**OFFICE OF RATEPAYER ADVOCATES
CALIFORNIA PUBLIC UTILITIES COMMISSION**

**Report on the Results of Operations
for
Pacific Gas and Electric Company
Test Year 2015
Gas Transmission and Storage Rate Case**

Chapter 4A
Hydrotest and
Vintage Pipe Replacement Programs

**Figure 4C-4
PG&E VIPER Program Decision Tree**

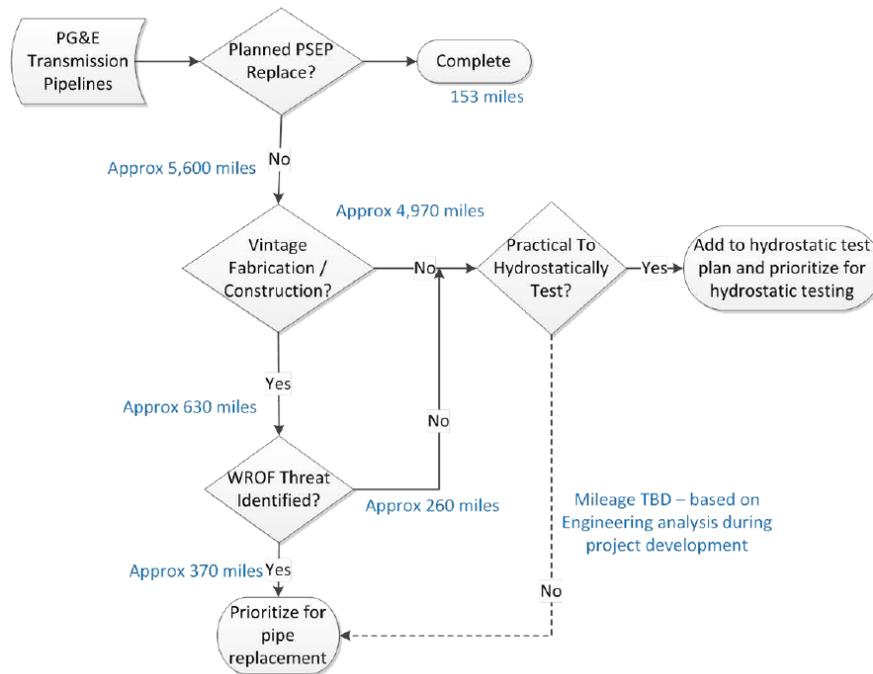
28 PG&E proposes to evaluate pipeline segments for replacement in the VIPER
29 Program using the VIPER decision tree, which is provided as Figure 4C-4 in Section
30 3.4.1 below. However, use of the VIPER decision tree is not optimal because PG&E's
31 VIPER decision tree improperly narrows the types of pipe which should be considered
32 for replacement beginning in 2015 to only those with vintage fabrication or construction
33 in locations susceptible to land movement. As discussed in Section 3.4.2 below, there
34 are a number of pipe segments posing other types of threats which would have been
35 identified for testing or replacement under the PSEP decision tree which would not

1 necessarily be mitigated under the VIPER decision tree. While PG&E has proposed to
2 include some of the deferred PSEP pipe segments in VIPER, this is not sufficient
3 because it is not clear that VIPER would identify those pipe segments for mitigation.
4 Consequently, PG&E should be required to explain how the VIPER decision tree should
5 be modified to address the deferred PSEP pipe segments and how mitigation for those
6 pipe segments will be prioritized.⁹⁵

21 PG&E's lack of transparency regarding deferred PSEP work is most clearly
22 illustrated by the proposed GT&S VIPER decision tree, in which the first decision point
23 fails to account for work that was planned and prioritized for replacement during PSEP,

1 but that was not completed. The following figure depicts the flow of projects through the
2 VIPER decision tree.¹⁶⁷
